August 11, 2015

Yukon Zinc Corp.
#701 – 475 Howe Street
Vancouver, British Columbia
V6C 2B3

Wolverine Mine
2015 Annual Physical Inspection of TSF and On-site Earth Structures

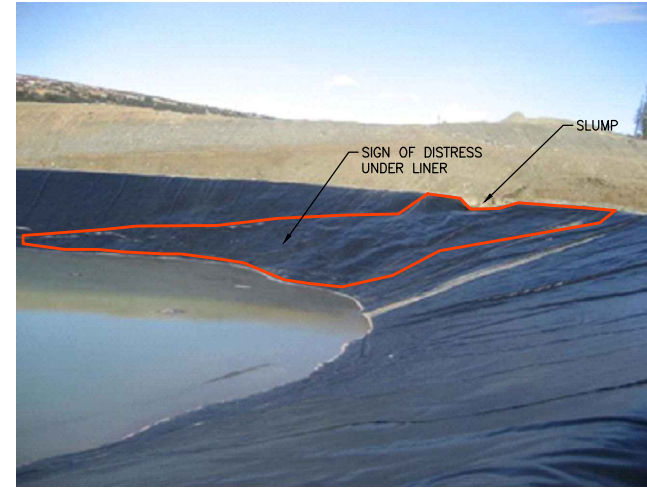
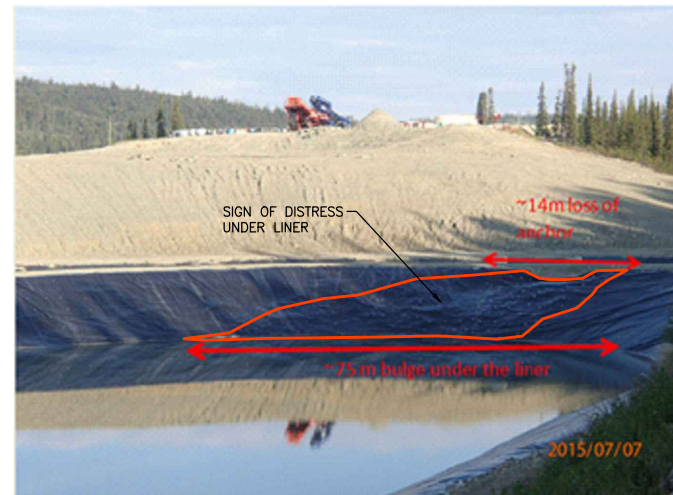
A slump along the north wall of the TSF has progressed to its current state over the last few years. A brief summary of field observations since 2013 is provided below and shown on Figure 3:

- 2013 observations: In the 2013 DSI cracking ranged from 1 mm to 7 mm wide was observed in this area along the crest of the impoundment. These cracks were not deeper and there was no slump or damage to the anchor of the liner noted.

- 2014 observations: In the 2014 DSI both a slump and tension cracks were reported in this area. The length of the liner affected by the slump was approximately 3 m along the anchor trench. Cracking observed in 2013 was reported to be reopened and was approximately 100 m long parallel to the crest and was 1 mm to 10 cm wide.

- 2015 observations: Slump along the anchor trench noticed in 2014 has deteriorated in 2014/15 and was approximately 14 m wide. The crest of the impoundment has been completely eroded with complete loss of anchor. Approximately 1.5 m of crest has been lost along the slump. The total height of tailings and water at the toe of the impoundment slope along the north end is less than 2 m and there was visible sign of distress in the slope underneath the liner under the slump and approximately 75 m west of the slump along the crest. At the slump location it appears soil underneath the liner has slid towards the downslope and created a bulge shape. No damage to the liner was visible due to this bulge except a puncture from an exposed rock (<5 cm). Tension cracks approximately 30 m long are visible upstream of the slump area but appear to be filled in with soil and are less than 10 cm deep.

The slump appears to be localized along the TSF slope and caused by an elevated water level. No tension cracks were observed upslope of the slump area in the crest or the waste dump during the site visit indicating a deep seated failure mechanism.

- Cover the entire slump area and cracks with a liner or equivalent product to prevent ingress of water from heavy rain events and spring melt. This cover should be placed before the winter season begins.
- Monthly survey of the slump area during the summer months.
- Visual monitoring on a weekly basis during the summer months.
- Immediately repair any damage to the liner caused by the slump.

- Upstream remediation: install a pumping system upstream of the slump area to lower the groundwater table.
- Downstream remediation: cut the existing liner from the slump area, excavate the slope, rebuild the slope with granular backfill to drain ground water to the existing underdrain system and replace the liner.
